DRAINAGE LETTER
FOR
STERLING RANCH RECYCLING FACILITY

June 2022
Project No. 25188.00
PCD Filing No:

Please update with
"PPR-22-041"

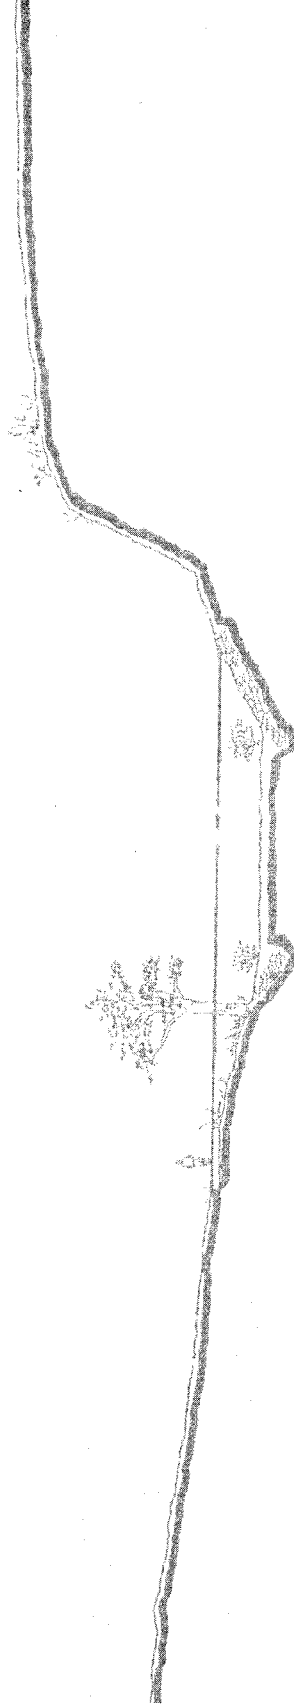
Charlene - Is Tc high?

JR Response: addressed.

JR Response addresses:
 Please see PCB File #: PR022941
 STERLING RANCH RECYCLING FACILITY
 EXISTING DRAINAGE MAP
 JOB NO. 25188.00
 DATE 03/27/20
 SHEET 1 OF 1

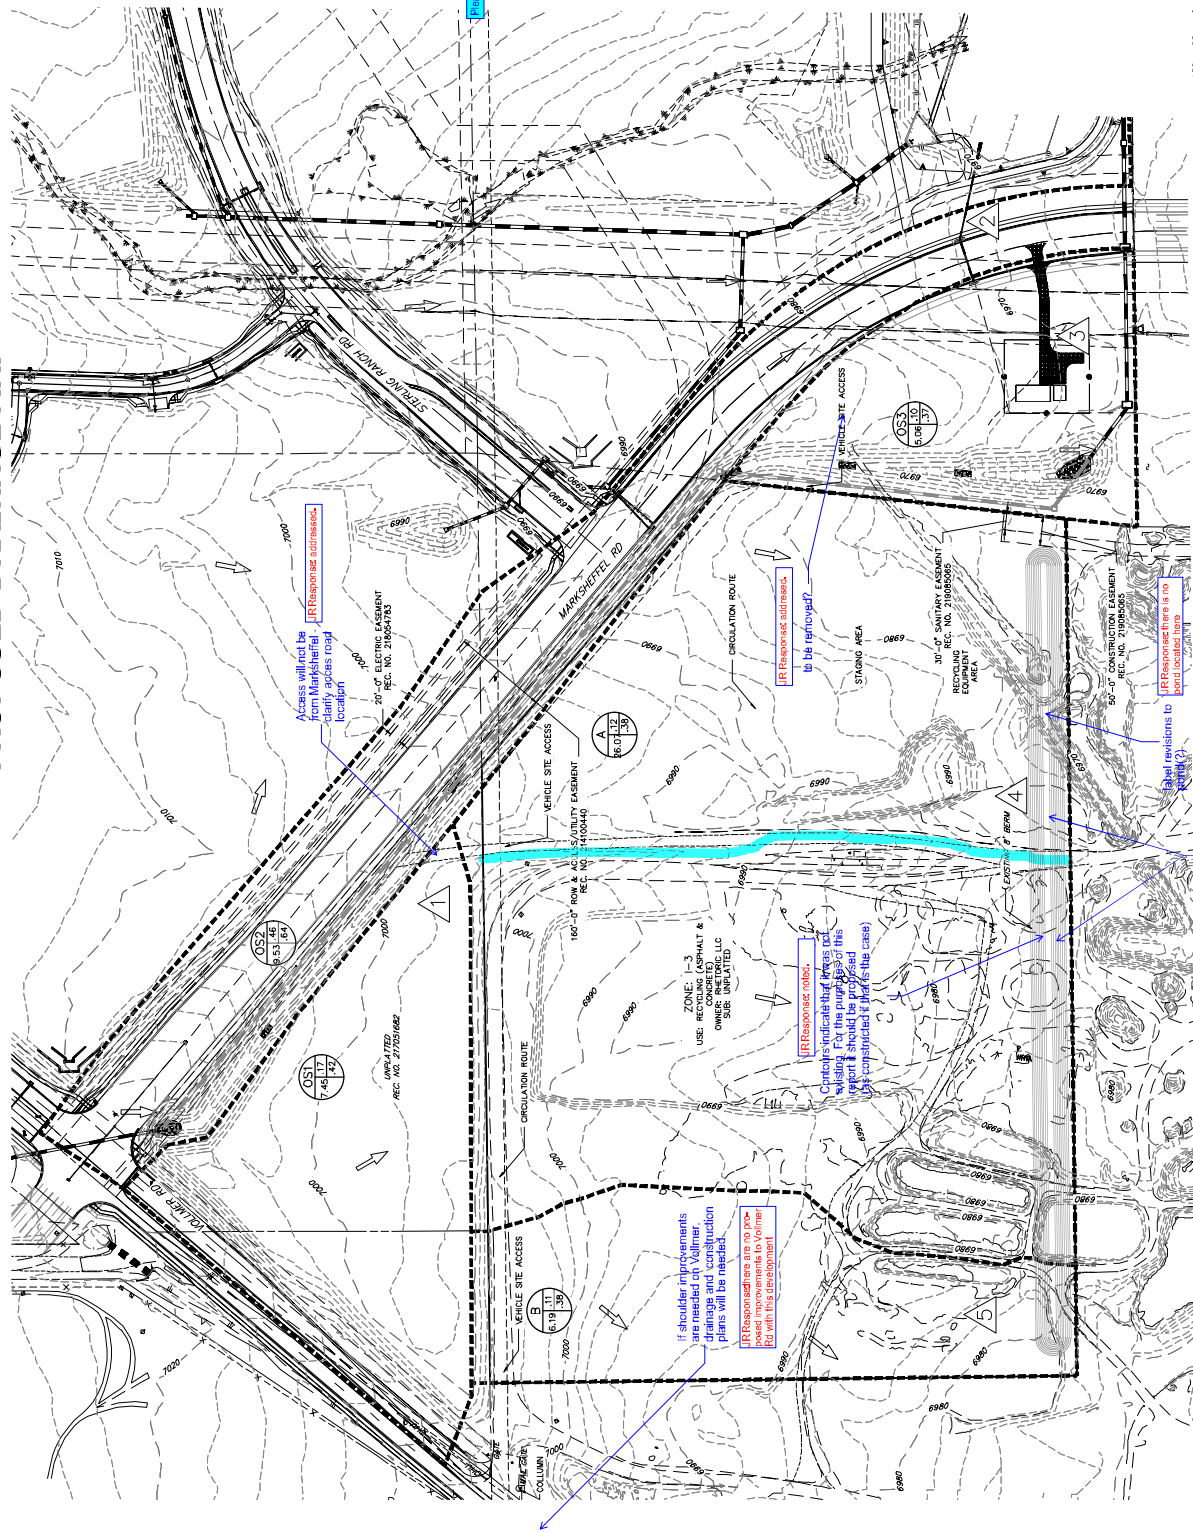
Provide pre-development and proposed drainage basins.
 Provide pre-development and proposed drainage basins.
 Provide pre-development and proposed drainage basins.
 Provide pre-development and proposed drainage basins.

Access will not be from Marksheliff. Identify access road location. [R]Response: address.

If shoulder improvements are needed on Volkmur, the construction plans will be resubmitted. [R]Response: are no pre-development plans. Ret with this submission.

But revisions to [R]Response: there is no need located here.

[R]Response: address. to be improved?.

[R]Response: notes. Contours indicate that areas to be retained for the purpose of this project are not restricted (in this case).

[R]Response: DPS, 4a & 4b, split the basin. No have been added.
